# Access Compliance Report

## Public Rights-of-Way

### (Curb Ramps)

Intersection ID: 11882	Main Street: N_PINE_ST	Cross Street: W_5TH_ST	Location: N
ADA ID: DD89CFFA98C3	Ramp Type: Perp	Initial Pass/Fail: Fail	Overall Compliance: No
		Severity Score: 12.5

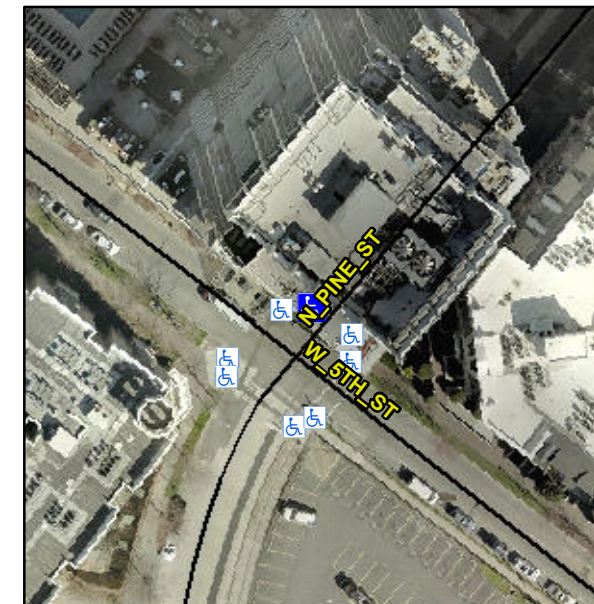
**R304.2.2**

Compliance	Description	Data	Compliance	Description	Data
N/A	Ramp Length (in)	76.0	No	Ramp Slope (%)	9.7
Yes	Ramp Width (in)	50.0	Yes	Ramp XSlope (%)	1.7
N/A	Flare Type LT	N/A	N/A	Flare Type RT	N/A
N/A	Flare Slope LT (%)	N/A	N/A	Flare Slope RT (%)	N/A
N/A	Flare Traversable LT?	N/A	N/A	Flare Traversable RT?	N/A
N/A	Landing Length (in)	N/A	N/A	DWS Provided?	N/A
N/A	Landing Width (in)	N/A	N/A	DWS Contrast?	N/A
N/A	Landing Slope (%)	N/A	N/A	DWS Length (in)	N/A
N/A	Landing X Slope (%)	N/A	N/A	DWS Full Width?	N/A
N/A	Landing Curb? (Y/N)	N/A	N/A	DWS Offset (in)	N/A
N/A	Shared Landing?	N/A			
N/A	Gutter Ponding?	N/A	N/A	Gutter Slope (%)	N/A
N/A	Gutter Lip Ht (in)	N/A	N/A	Gutter X Slope (%)	N/A
N/A	Painted X Walk1?	Yes	N/A	Painted X Walk2?	N/A
	X Walk 1 Direction	To SE		X Walk 2 Direction	N/A
N/A	X Walk 1 Width (in)	100.0	N/A	X Walk 2 Width (in)	N/A
	X Walk 1 Slope (%)	1.0		X Walk 2 Slope (%)	N/A
	X Walk 1 X Slope (%)	5.8		X Walk 2 X Slope (%)	N/A

**Remove & Replace Entire Ramp.**
